**202 HILLTOP DRIVE  
UPPER NYACK, NY 10960**

**PROJECT NARRATIVE**

- WALLS TO BE NATURAL STONE
  - EXTENSION OF CURBING INTO SEEDED AREA ON BLISS LANE
  - NO LIGHTING TO BE LOCATED ON SOUTH SIDE OF PROPERTY
- COMMENT PROVISION RESPONSES:**  
ORIGINAL COMMENTS PROVIDED BY:  
PLANNING BOARD OF THE VILLAGE OF UPPER NYACK  
WEDNESDAY, NOVEMBER 18, 2009

**FINAL SITE PLAN**

**A SITE PLAN**  
SCALE: 1" = 20'-0"

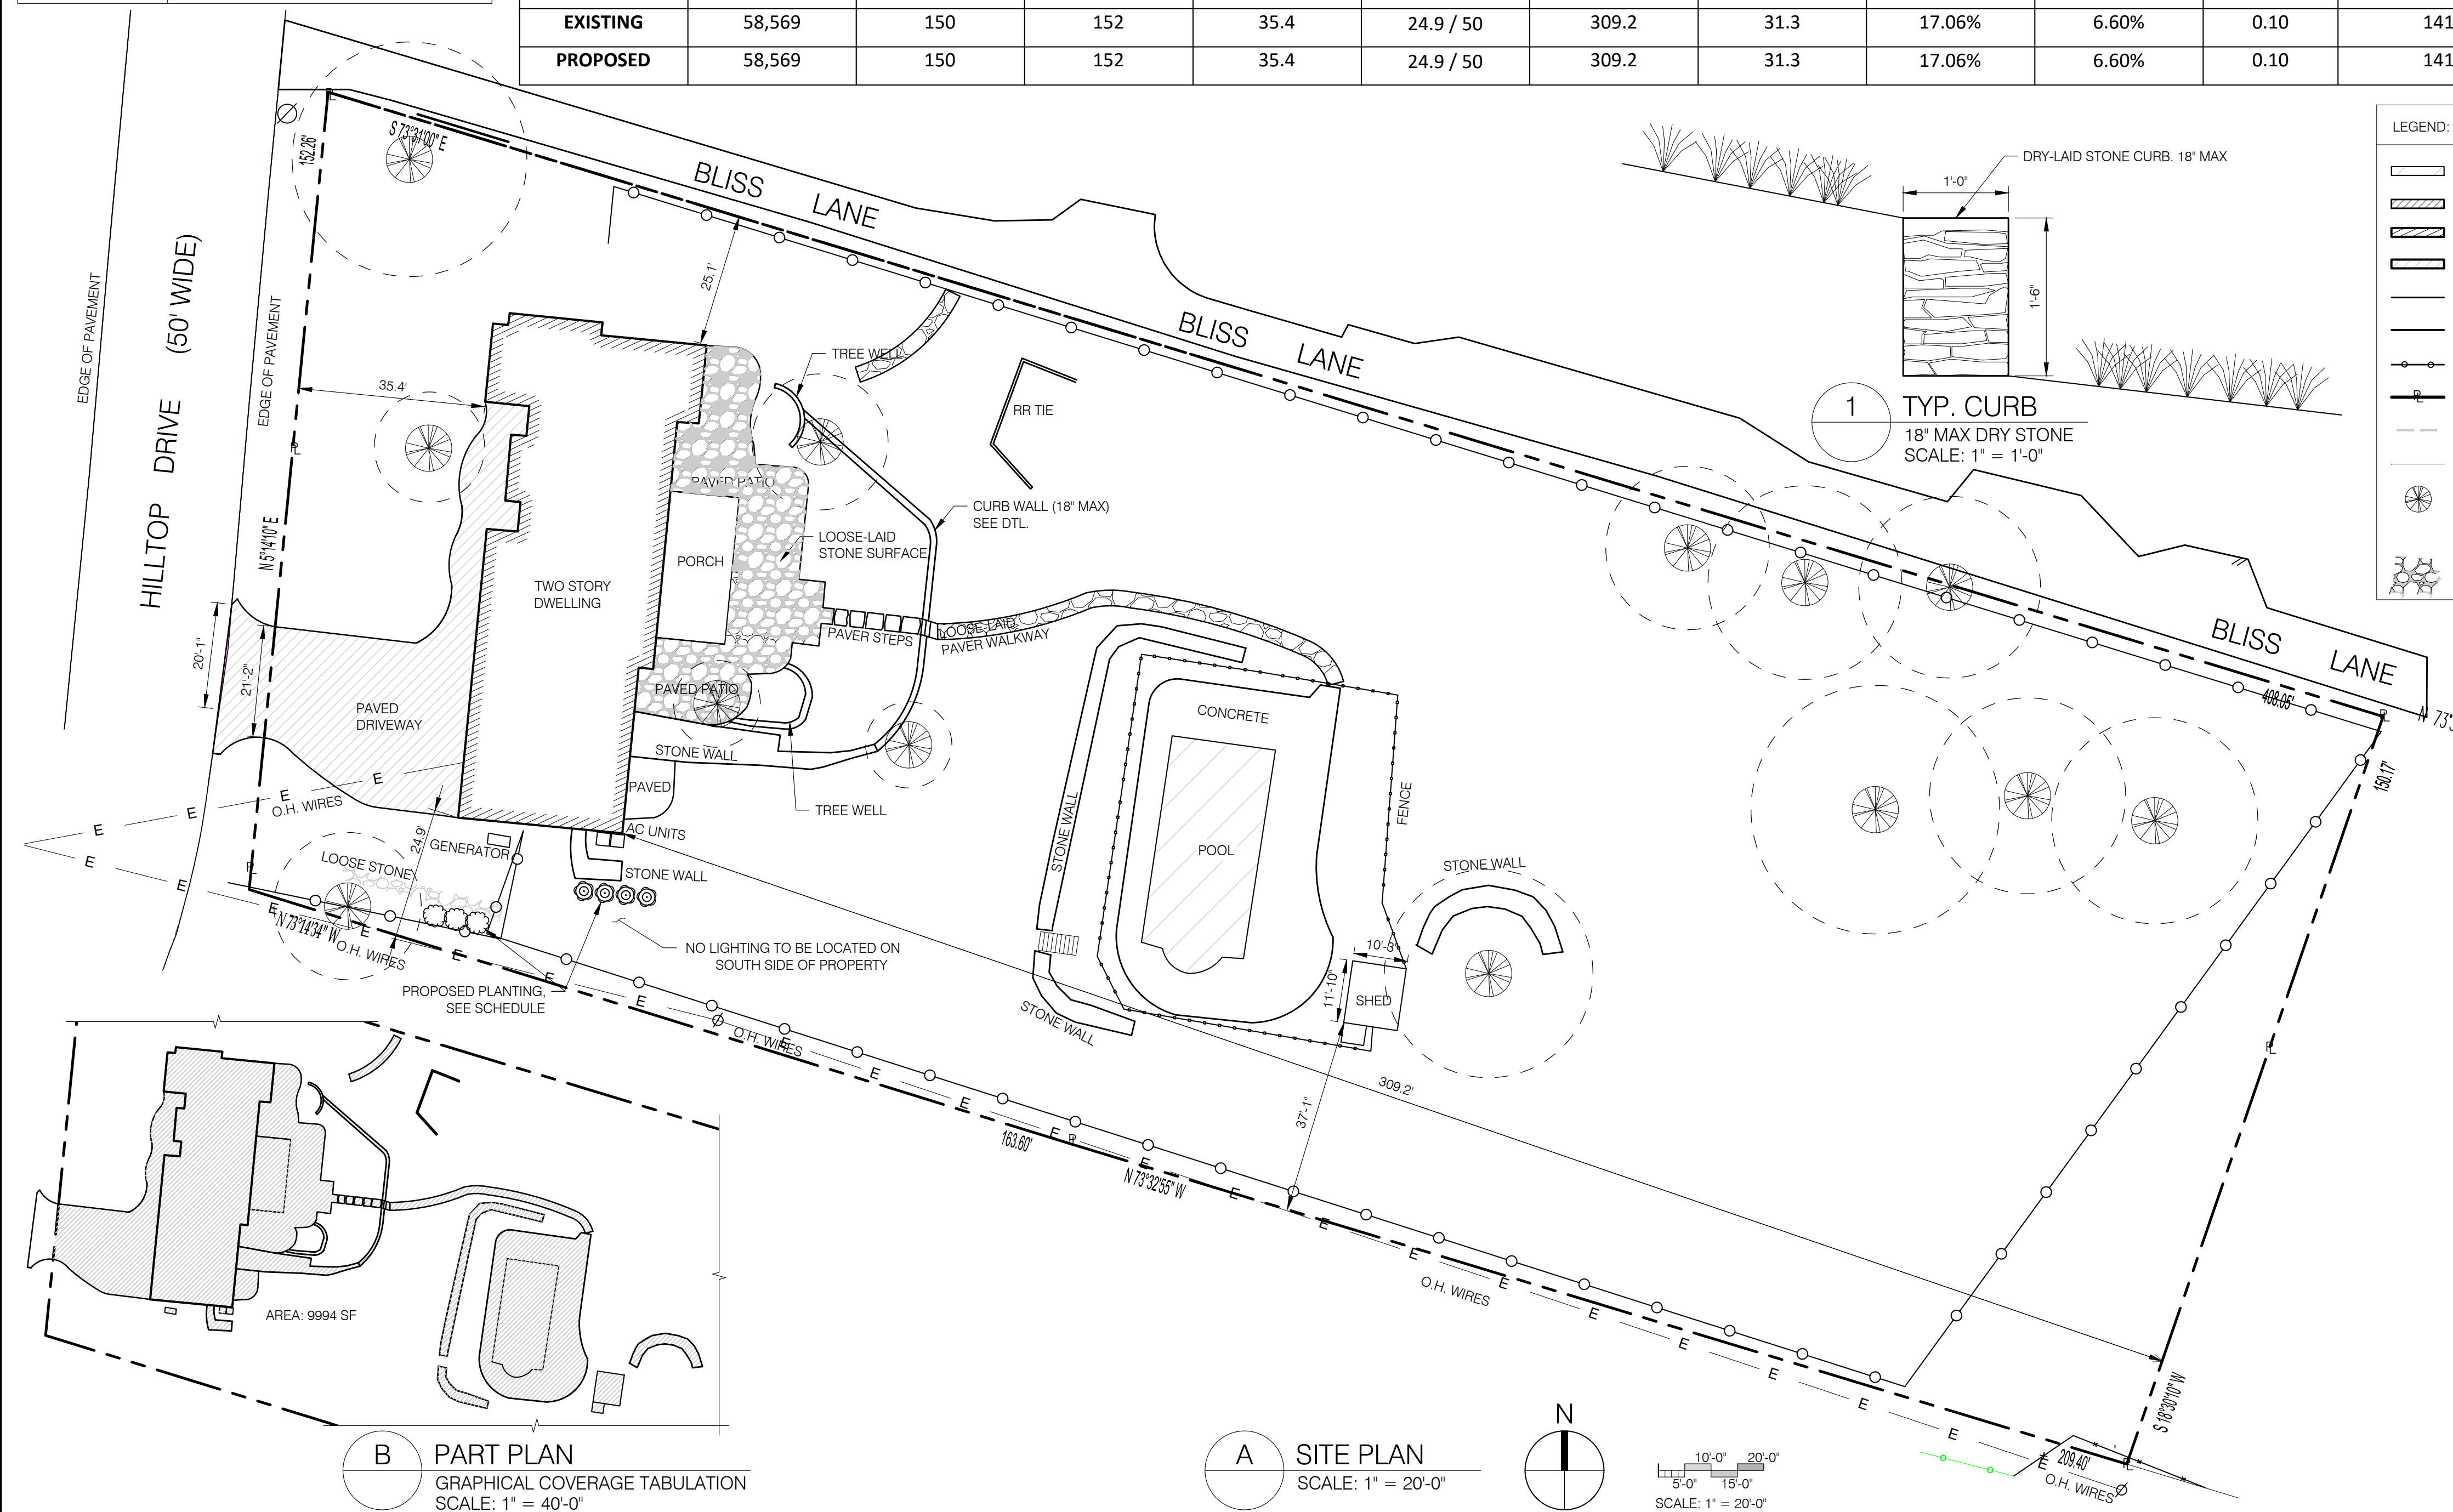
COMMENT RESPONSES FOLLOW
- SHOW DIMENSIONS OF POOL HOUSE  
POOL HOUSE DIMENSIONS HAVE BEEN ADDED
  - RELOCATE AC UNIT/COMPRESSOR ON SOUTH SIDE OF THE HOUSE TO BACK OF HOUSE  
EXISTING SLIDING DOORS PRESENT AT SOUTH SIDE OF HOUSE, AC COMPRESSOR INSTALLED AS SHOWN AND SCREENED WITH RUBBLE EMBANKMENT AND PLANTING SCREENING

- ADD NOTE STATING WALLS TO BE NATURAL STONE (NOT CONC.)  
NOTE ADDED
  - ADD NOTE STATING EXTENSION OF CURBING INTO SEEDED AREA ON BLISS LANE  
NOTE ADDED

- ADD NOTE STATING NO LIGHTING TO BE LOCATED ON SOUTH SIDE OF PROPERTY  
NOTE ADDED
